Unapproved minutes P802.3bs 400 Gb/s Ethernet Electrical Ad Hoc Teleconference 29 February 2015

Title: Electrical Interface Ad Hoc Opening/Agenda

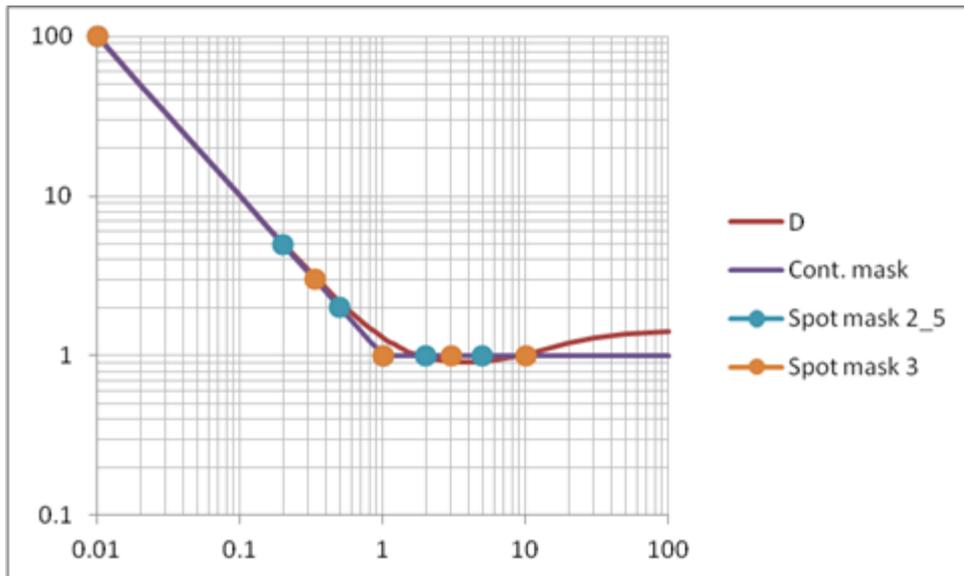
Andre showed D1.2 Comment #58 (Piers Dawe) regarding 5 or 6 jitter tolerance frequencies, as it pertains to the open work-item on increasing the number of jitter tolerance frequencies. Piers asked that the following diagram illustrating these spot frequencies be shown, Andre allowed it.

There was a follow-on discussion on CDR bandwidth and whether 4 or 2 MHz is needed. Ali and Andre both commented that there is interest in Electrical transceivers that can handle both 50G backplane and CDAUI-8 signalling. Such (DAC/DSP) implementations will have much lower Rx bandwidth. Discussion then continued on the related issues such as the potential effect of cascaded jitter peaking.
